Australian Air Publication 721.79

# VAMPIRE MODIFICATIONS

(Nos 401 to 500)

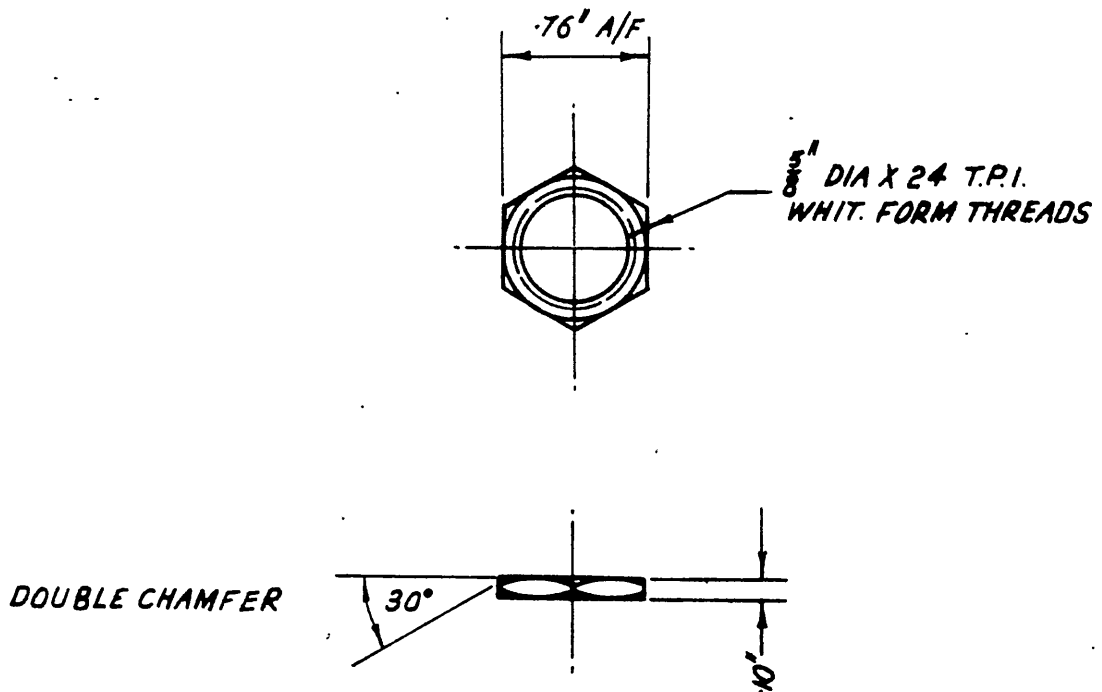
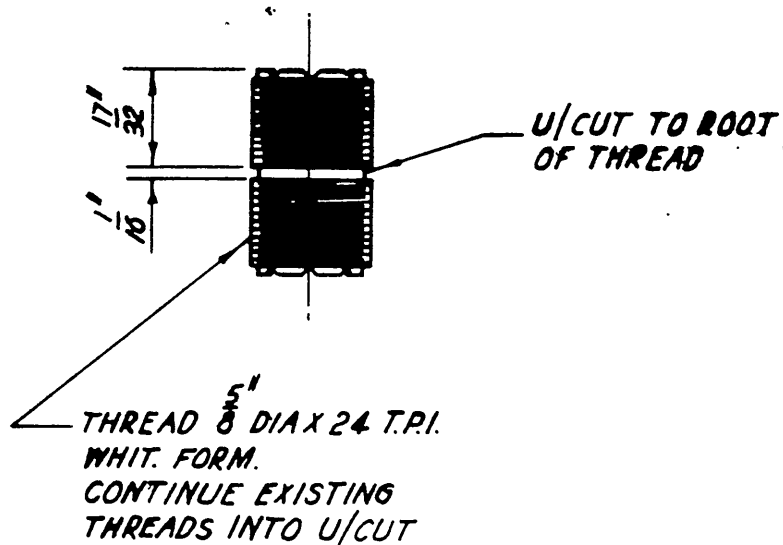
12. (a) Manufacture lock nuts (2 off) in accordance with Drawing No DA66217000 using item 1.
- (b) Open the nose cap and disconnect the aircraft batteries.
- (c) In the main undercarriage wheel wells remove the two access panels situated on the rear walls.
- (d) Open the lower inspection door to gain access to the engine bay.
- (e) Locate the existing junction boxes through the panels in the wheel wells and disconnect the connector from the engine bay and undo all ties.
- (f) Working from the engine bay, pull the disconnected connector back along the conduit until the wing break joint becomes visible at the engine bay end.
- (g) Undo the joint and remove the straight connector.
- (h) Obtain completely threaded connector with lock nuts and couple up both ends of the existing pacitor cable finger tight and lock with spanners on centre lock nuts.

<b>DEPARTMENT OF AIR</b> ISSUED BY SENIOR TECHNICAL STAFF OFFICER SUPPORT COMMAND			TITLE FITMENT OF MK35A WINGS TO MK35 AIRCRAFT	
DRAWN L.O.W.	CHECKED <i>Hutchins</i>	APPROVED <i>[Signature]</i>	MODIFICATION NUMBER VAMPIRE NO 449	DRAWING NUMBER DA66190000

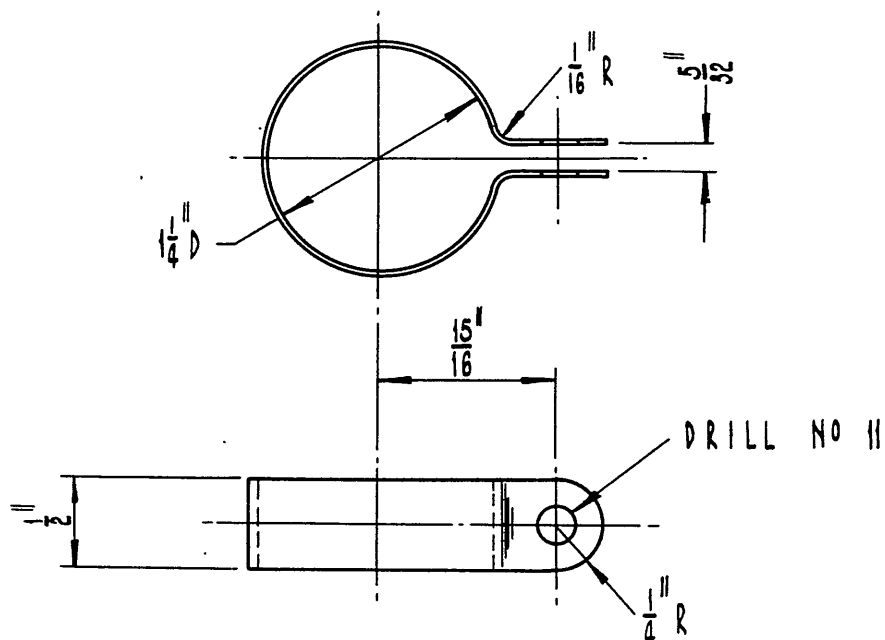
- (f) Refer to the attached Drawing No 66190000 and manufacture clip (item 12) (qty 2) from item 28.
- (g) Make up items 5, 15, 40, 42, 44, 45, hose couplings, from items 6, 16, 41, 43, 46 respectively.

<b>DEPARTMENT OF AIR</b> ISSUED BY <b>SENIOR TECHNICAL STAFF OFFICER</b> <b>SUPPORT COMMAND</b>			TITLE SWITCH GUARD EMERGENCY LIGHT	
DRAWN  	CHECKED <i>[Signature]</i>	APPROVED <i>[Signature]</i>	MODIFICATION NUMBER VAMPIRE MOD 448	DRAWING NUMBER DA66123 000

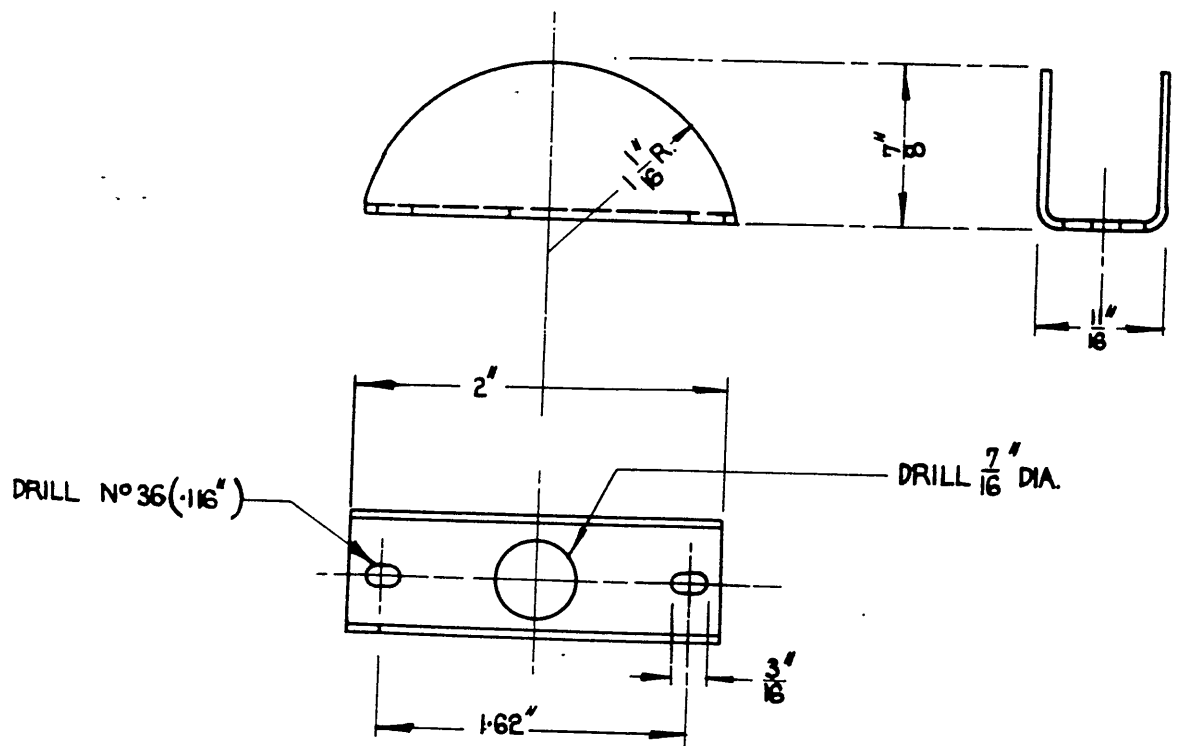
12. (a) Using item 1, manufacture guard in accordance with attached drawing. Finish matt black.
- (b) At top left hand side of centre instrument panel shroud, remove and retain the emergency light switch mounting screws.
- (c) Fit manufactured guard over switch toggle and secure with the mounting screws retained above.

A15891  
SHT 1 OF 25HTS.

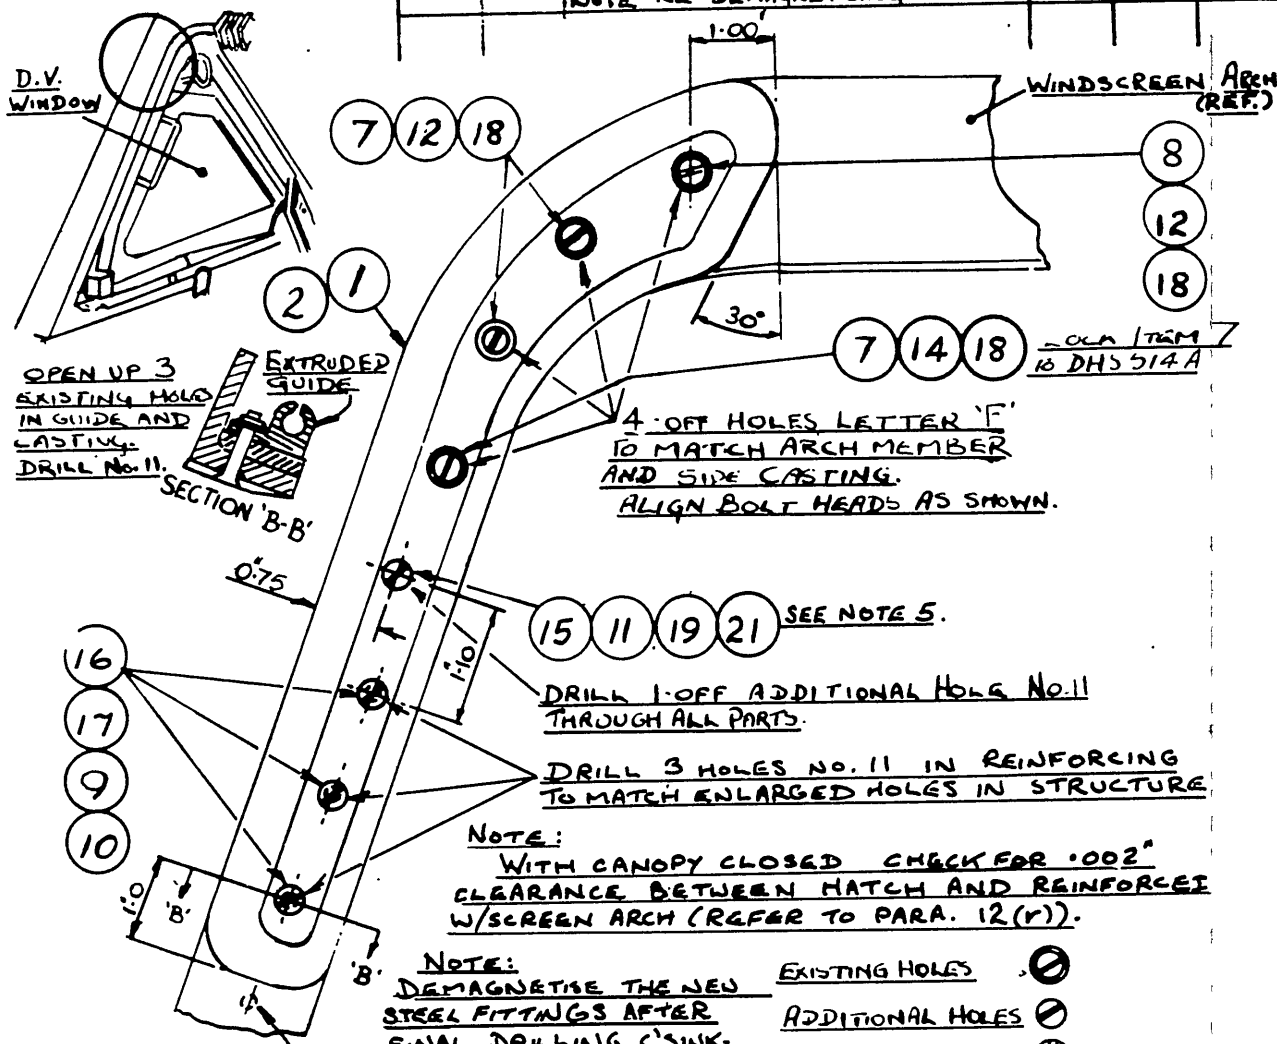
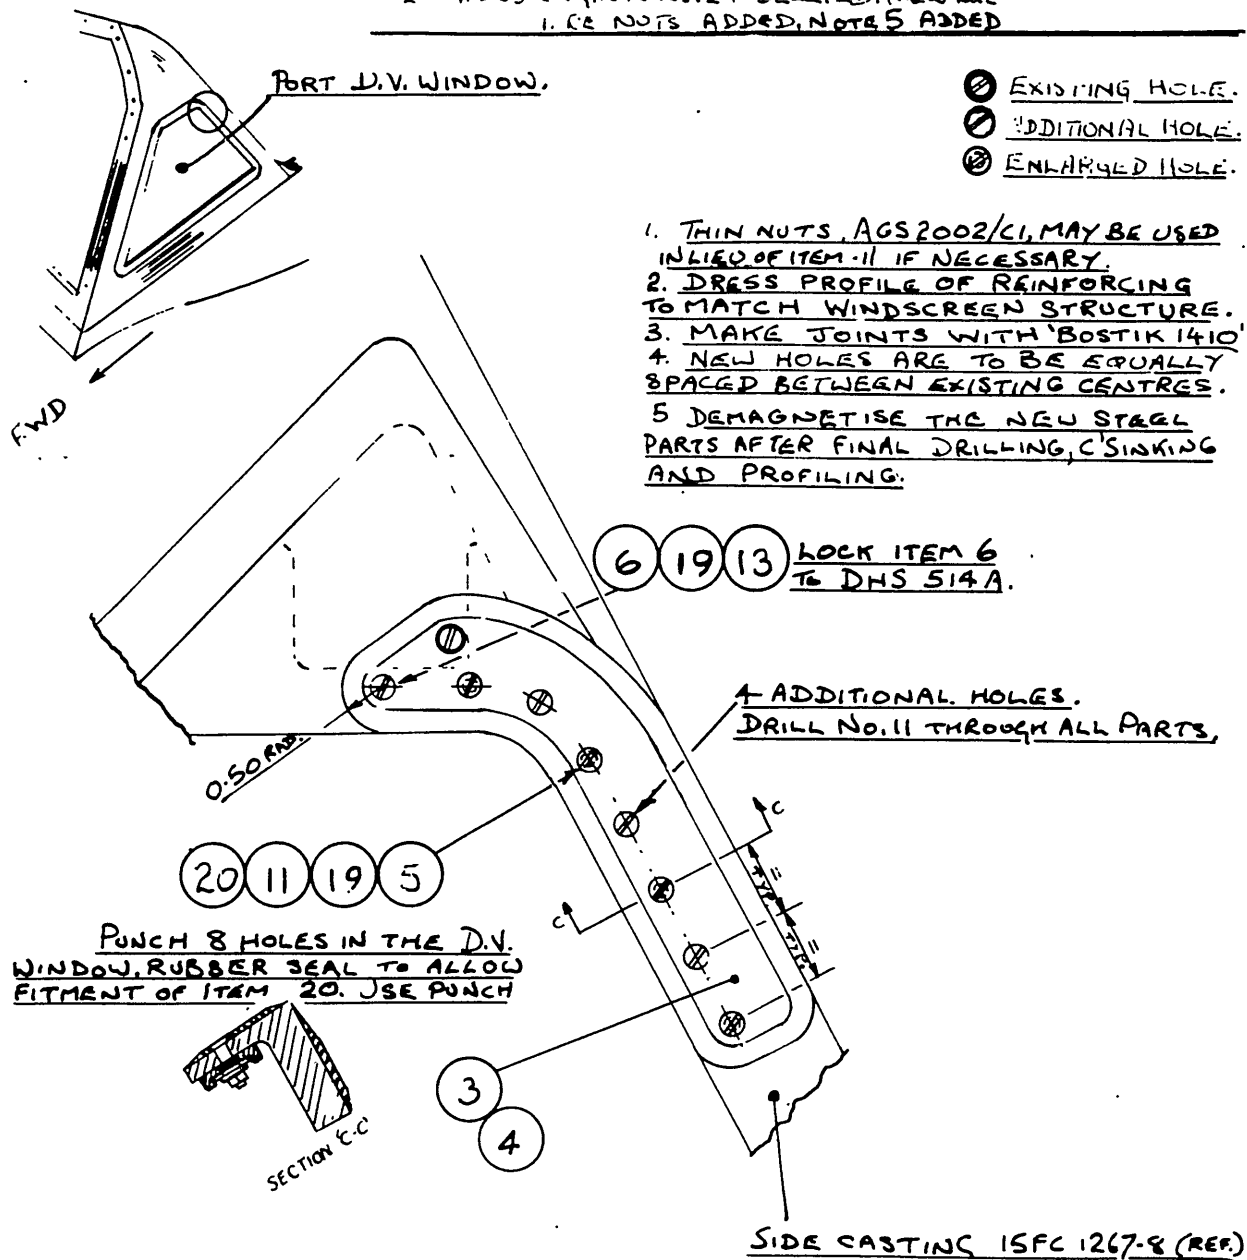
- (b) Refer to Drawing No A15891 sheet 1. From the aft face of the windscreen side casting, remove the four 4BA bolts securing the extruded guide Part No 15FC-2933 (ref), retaining only one bolt.

- (k) Coat all mating faces with "Bostik 1410", then secure all items in position with their attachments as shown on sheet 1 of the drawing. Remove the surplus threads of the top five bolts where necessary ensuring that the bolt heads are flush and that the slots are aligned as shown. Secure the retained 4BA bolt in the lowest hole of the side casting and extruded guide.

- (m) Refer to sheet 2 of the drawing. Remove one 2BA and four 6BA redundant bolts, nuts and washers from the positions shown in the side casting. The four 6BA holes are to be re-drilled No 11.

- (p) Fill the countersunk area of the top existing hole in the side casting with "Hermetal" filler (item 24).
- (q) Coat all mating surfaces with Bostik 1410 (item 22) then secure the reinforcing to the side casting with the attachments shown on sheet 2 of the drawing. Remove surplus threads where necessary.

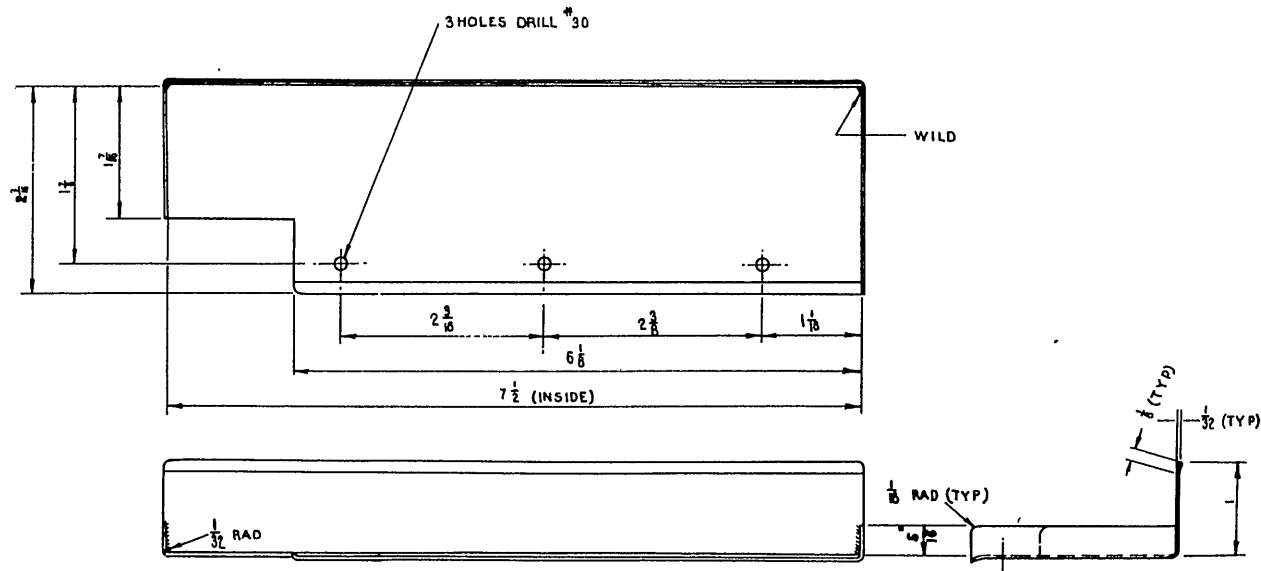
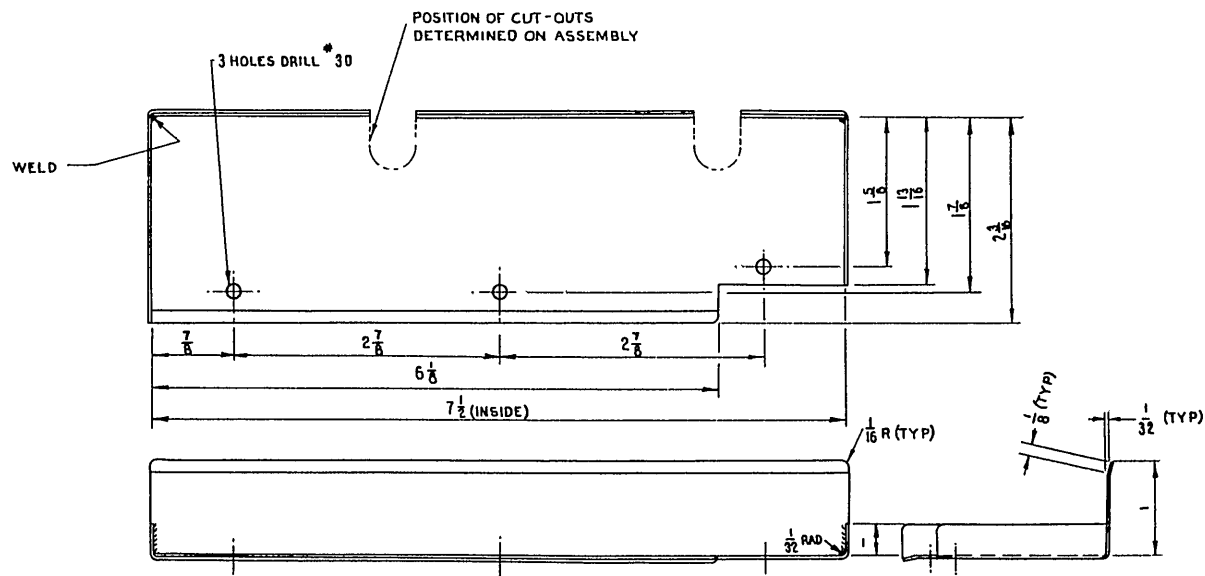
12. (a) Manufacture cover assemblies to the dimensions and specifications as shown on the Drawing A15433.
- (b) Open the port and starboard ammunition bin doors.
- (c) Locate the opening in the bottom of the port rear ammunition bin and fit cover plate (item 3), using three round headed wood screws (item 1).
- (d) Remove pneumatic system air bottle from position on the starboard rear ammunition bin.
- (e) Locate the opening in the bottom of the starboard rear ammunition bin and fit cover plate (item 4), using three round headed wood screws (item 1). Ensure that the two pneumatic lines (P/Nos S15-1071 and S15-1075) do not chafe on the cover plate.
- (f) Refit the pneumatic system air bottle and wire lock the connections and retaining strap bolt. Inflate the pneumatic system to 450 psi and test for leaks.
- (g) Close the port and starboard ammunition bin doors.

FIG. 1. VIEW SHOWING POSITION OF HOLE IN INSTRUMENT PANEL

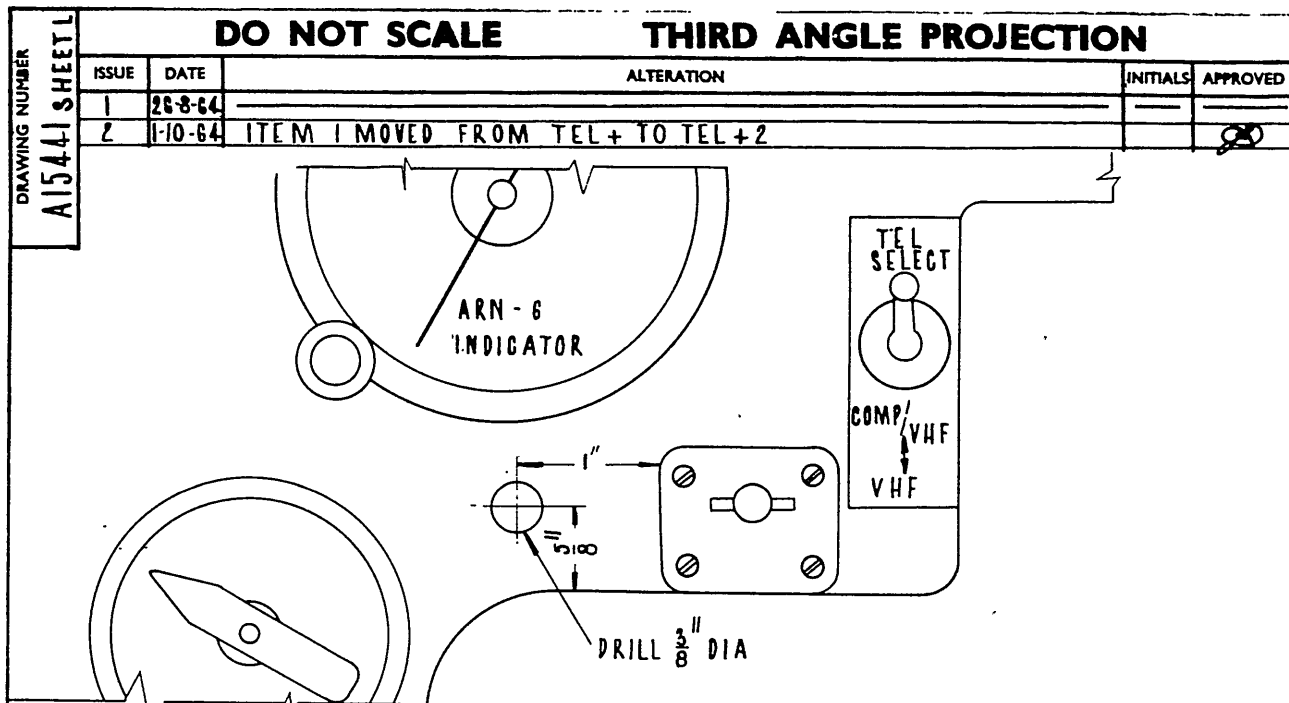
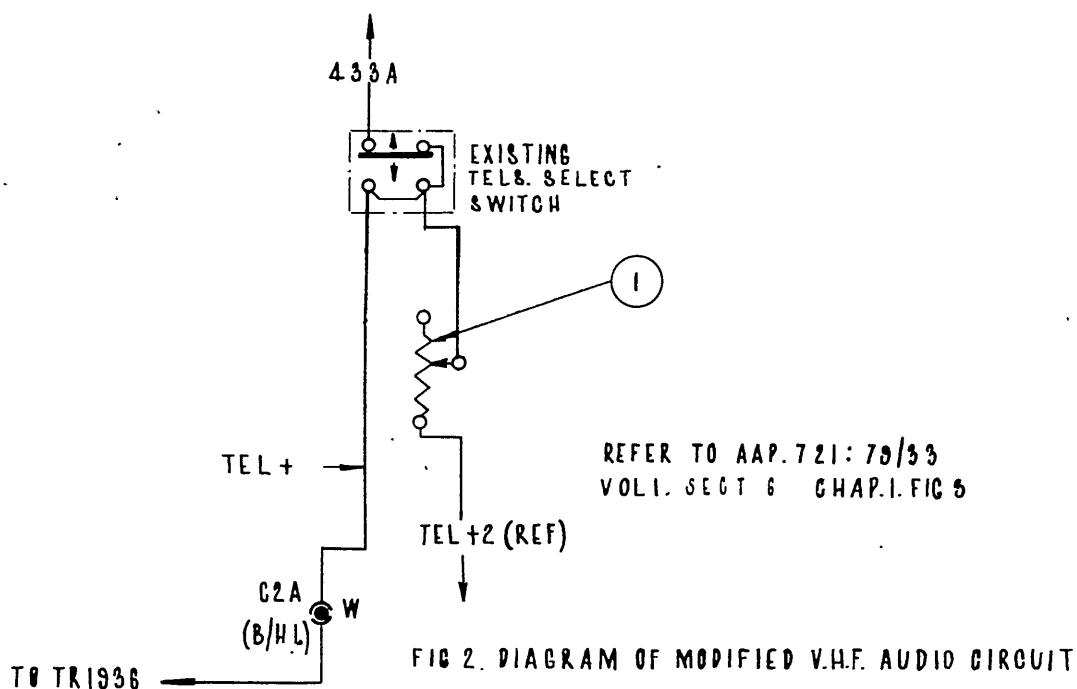
Drill a 3/8" diameter hole in the instrument panel as shown in Drawing No A15441 Sheet 1 (Issue 2) Fig 1. (Ensure all swarf is collected and removed from cockpit).

- (i) Solder 6 inches of cable (item 3) to the centre terminal of the potentiometer (item 1). Cover this joint with 3 mm PVC sheathing (item 6).
- (ii) Refer to Drawing No A15441 Sheet 1 (Issue 2) Fig 2. Disconnect the Tel +2 wire from the Tels Select Compass/VHF-UHF switch.
